**Re: Hidden Quarry
Burnside Letters of April 24, 2015
Burnside Project No.: 300032475.0000**

We are pleased to respond to the R.J. Burnside and Associates letters of April 24, 2015 in regards to the Hidden Quarry application. There are only a few comments required. We have retained the same section numbers for cross comparison.

Response to comments on Hidden Quarry Specific Well Contingency Plans

Figure 1: MW2 and OW13D Response to Mushroom Farm Pumping

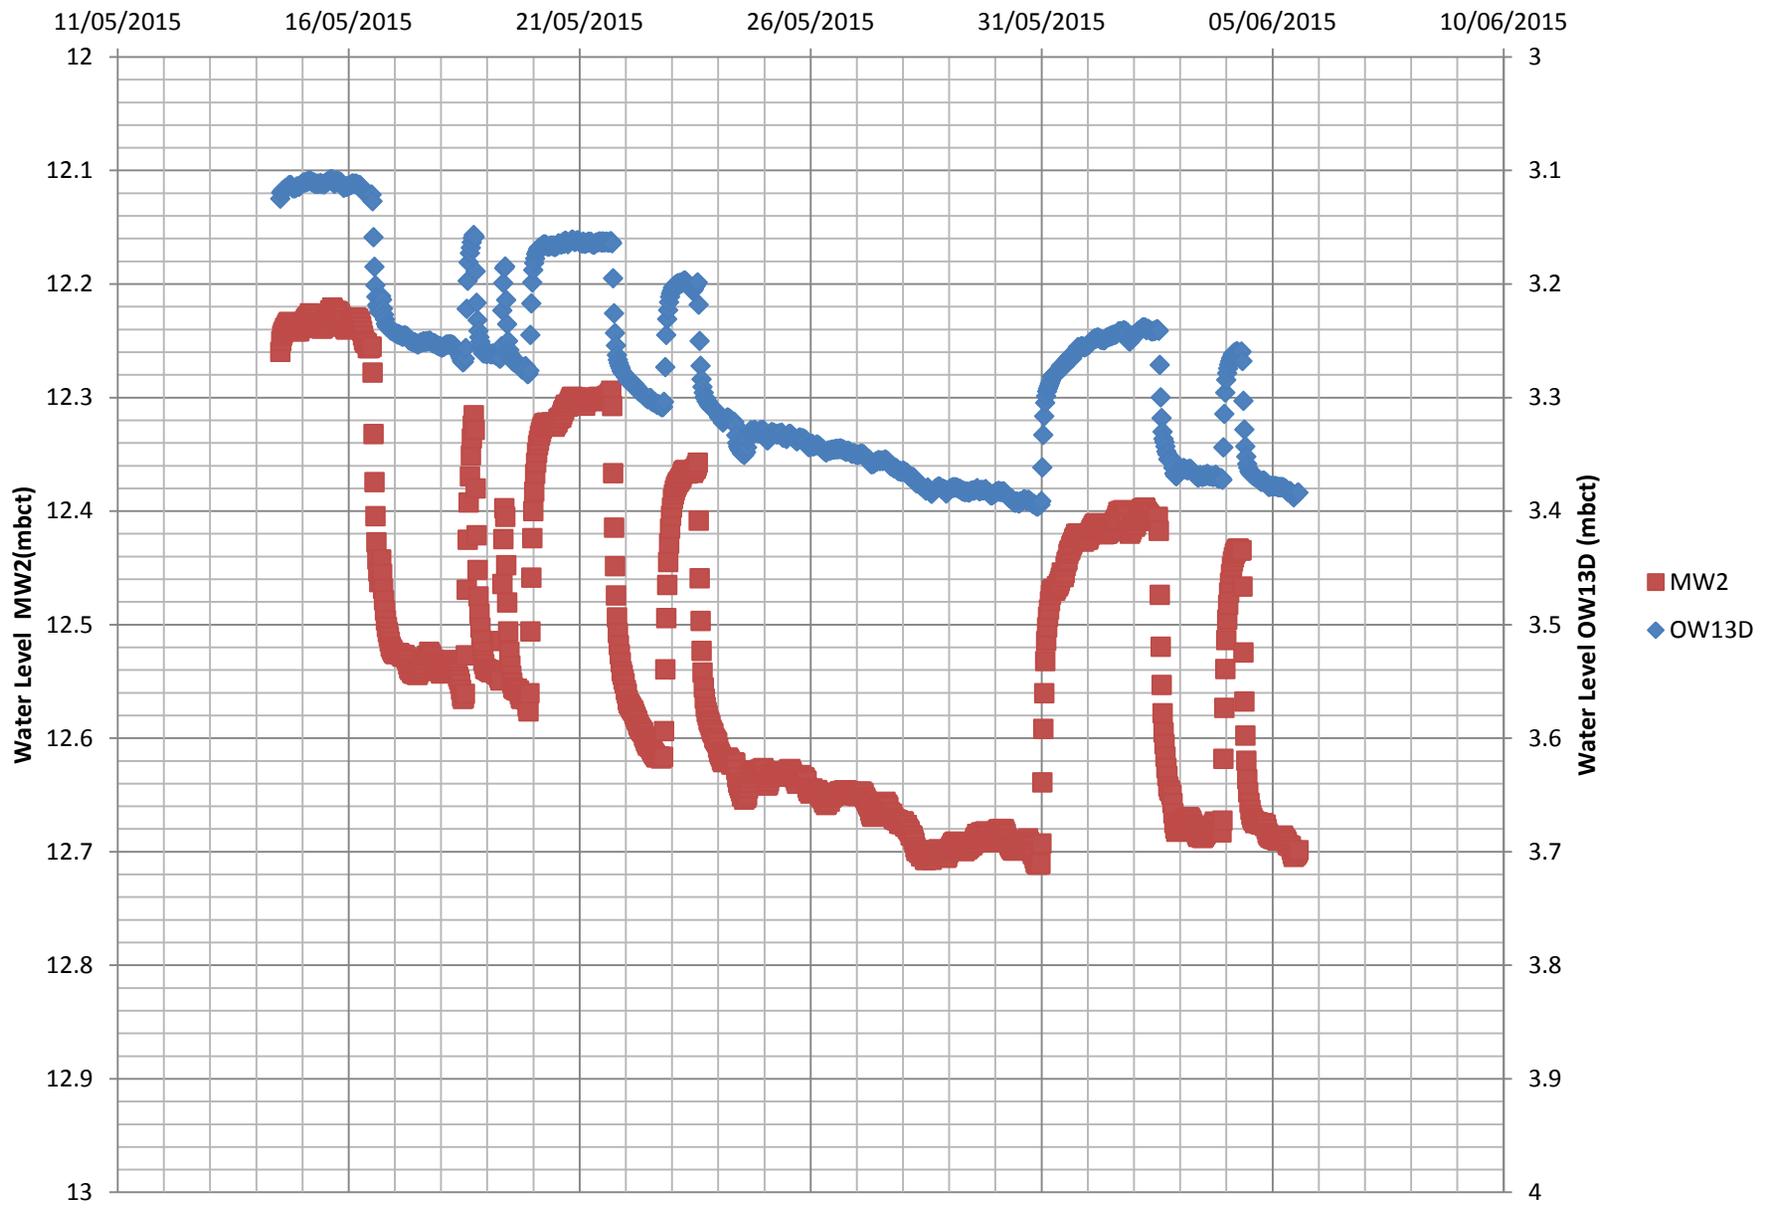
2. Wells W2 and W3 on the Mushroom Farm property

To understand the wells on the mushroom farm a brief description of their use is necessary. W3 is a deep bedrock well that is used to pump large volumes of water (approximately 80 gallons per minute) to the cooling system in the mushroom barn. A series of pipes and heat exchangers raise the temperature of the water and lower the temperature of the air. The warm water is then recharged into W2, a shallow dug well used as an injection well. There is neither a Permit to Take Water nor an Environmental Compliance Approval for a Sewage Works in place for this system even though one would normally be required. W2 was measured to be 3.97 metres deep with a static water level of 2.42 metres below casing top (April 29, 1998). The well had a concrete casing with plywood cover. The well owner said that it dried up in the summer.

W3 is 54.86 metres deep and is open from the top of the dolostone formation to the top of the shale formation (44.8 metres). Graham Well drilling pumped the well at a rate of 80 US gpm and static water level was drawn down to 40.8 m below casing top after 45 minutes. The recommended pump setting is 48.8 m below casing top. Water was 'found at' depths of 36.5 m and 50.3 m, both below the proposed depth of the quarry. The water level during pumping is estimated to be 319 m AMSL which is eight metres below the proposed depth of the quarry and about 28 metres below lowest allowable water level in on-site monitors during extraction phase. The quarry represents a significant potential recharge boundary for Well W3. To our knowledge none of the neighbours have complained about this water use despite the pumping by the Mushroom Farm that has a drawdown more than ten times that of the proposed quarry. On the day of a site visit in 2011, the owner and I could hear the cavitation of the pump, indicating that the water was being lowered to the pump intake level, presumably at the recommended pump depth of 48.8 metres.

Figure 1 shows the on-site response in a shallow (OW13D) and deep well (M2) well to pumping at the Mushroom Farm. The farm well was pumped continuously during a hot

spell between May 23 and May 30, 2015. The maximum response in the shallow bedrock well OW13D at a distance of 150 metres was 0.11 metres and the response in the deep well (M2) at a distance of 215 metres was 0.26 metres. It is our assumption that the pumping well is being operated as observed in 2011 and as recorded on the water well record and has an approximate drawdown of 48 metres. The minimal interference observed on-site verifies that the interference from the proposed 2.54 metre water level change in the quarry will have a negligible impact on private wells north of the quarry along 6th Line Eramosa.
